**RE: Response to Comments from Proposed Data Center Noise Impact Assessment
1960 W. Lucent lane, Naperville, Illinois 60563**

Jacob and Hefner Associates, Inc. (JHA) is pleased to present this Response to Comment (RTC) letter addressing recommendations and inquiries from Hampton, Lenzini and Renwick, Inc.'s (HLRs) review titled *Karis Critical Development (1960 W. Lucent Lane) – Review of Noise Impact Assessment Report and Recommendations*, dated October 2, 2025. Specific alterations to the model, comparisons of model output to regulatory limits, and clarification of model details, as noted in HLR's review, are addressed in the updated Noise Impact Assessment (NIA) (**Attachment 1**) and in responses below.

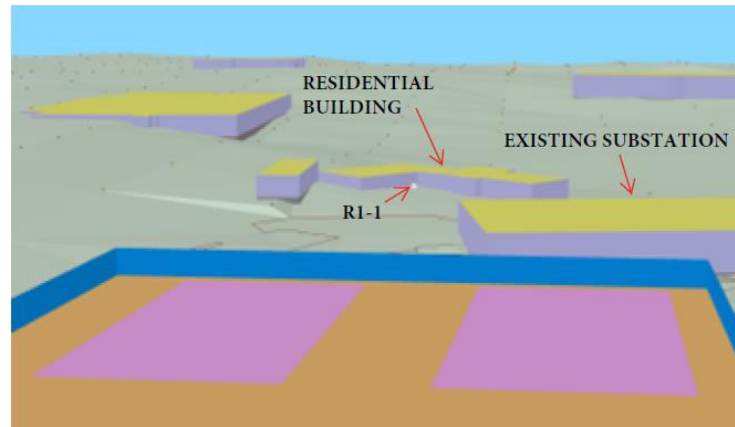
“Please confirm that the ‘auxiliary’ building representing the substation is accurate size and shape in SoundPlan to ensure accurate shielding effects”

The existing substation building and walls shielding the R1-1 receptor from property-line noise sources is set at 19 feet in total height. The corners of the building/walls are set into the ground slightly. Though the height is variable above ground given the variation in grade, the height near the corners of the wall nearest to the R1-1 receptor are approximately 16 feet in height. Since most of the noise impact at R1-1 is from rooftop HVAC units, and the substation does not break line of sight from the top of the parapet wall with the current receiver location. The shielding effects of the substation walls are not significantly effective in reducing noise propagation from the proposed data center noise for the current Leq-N model (Figure 4 on the NIA). A 3D image of the line-of-sight between the rooftop parapet and Receiver R1-1 is provided below for visual context.
